RE: Premier Elkhorn Coal Company
Permit No. 867-5294 Am. #1 KPDES Permit Application
Notice of Deficiency Response

Re: **Joe's Branch; Letcher County**
KPDES# **KYG046222**
DNR# **867-5294; Am #1**
AI# **85370**

Permit Application for General Permit Coverage For Coal Mining Operations

JENKINS EAST QUADRANGLE
KENTUCKY-VIRGINIA
7.5 MINUTE SERIES (TOPOGRAPHIC)
NE/4 POUND 15' QUADRANGLE

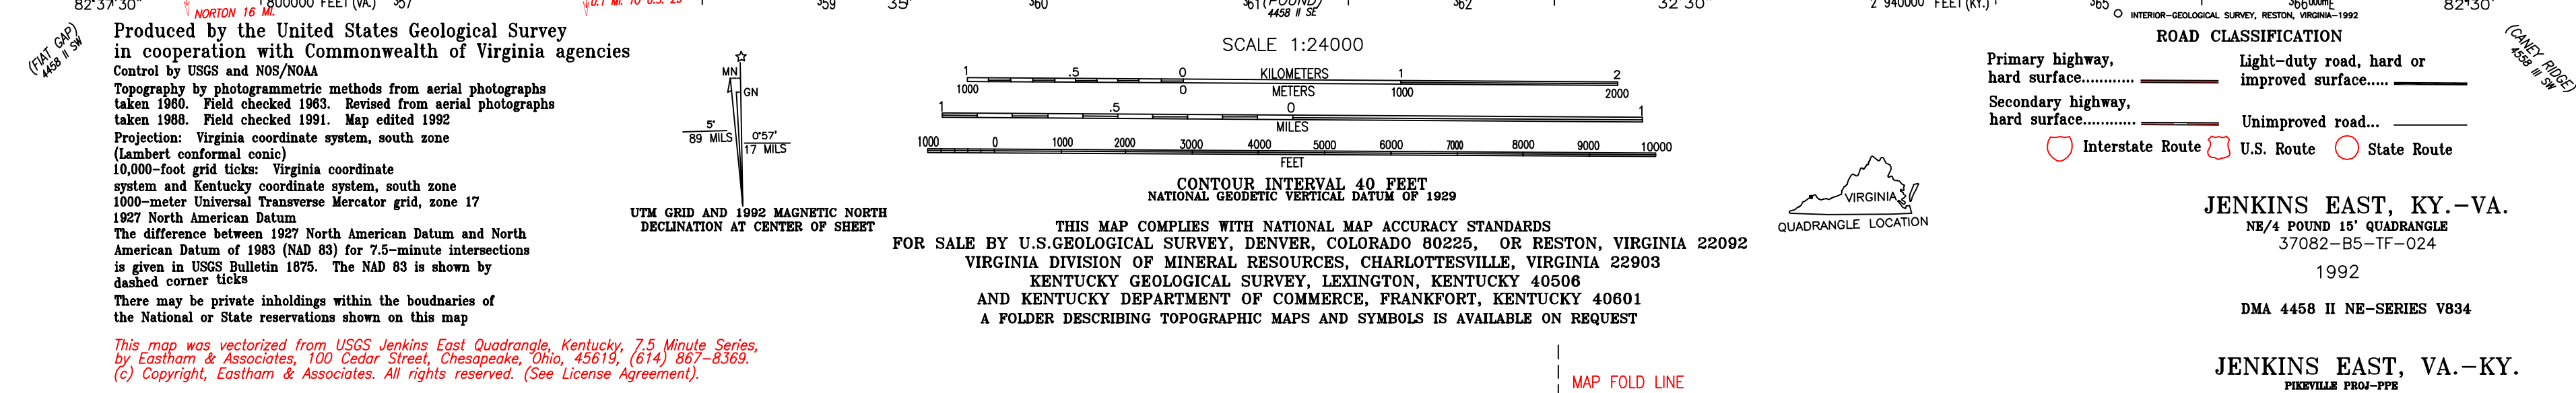
- Applicant shall complete Section II - "General Site Information" by providing a full-sized 7.5 minute USGS Quadrangle location map; the Mining and Reclamation Map; and the Environmental Resources Information Map.

Please find attached the updated SDAA and NOI forms as requested. A full sized USGS quadrangle map has been provided showing the existing and proposed portions of the permit area. The MRP and ERI map have also been attached. No effluent characteristics were analyzed due to the fact that all structures are on-bench with no discharges occurring into the Joes Branch Watershed. Contact information has been provided in the NOI form itself for primary company contact and company officer(both being Stacy Billiter) and the NOI preparer.
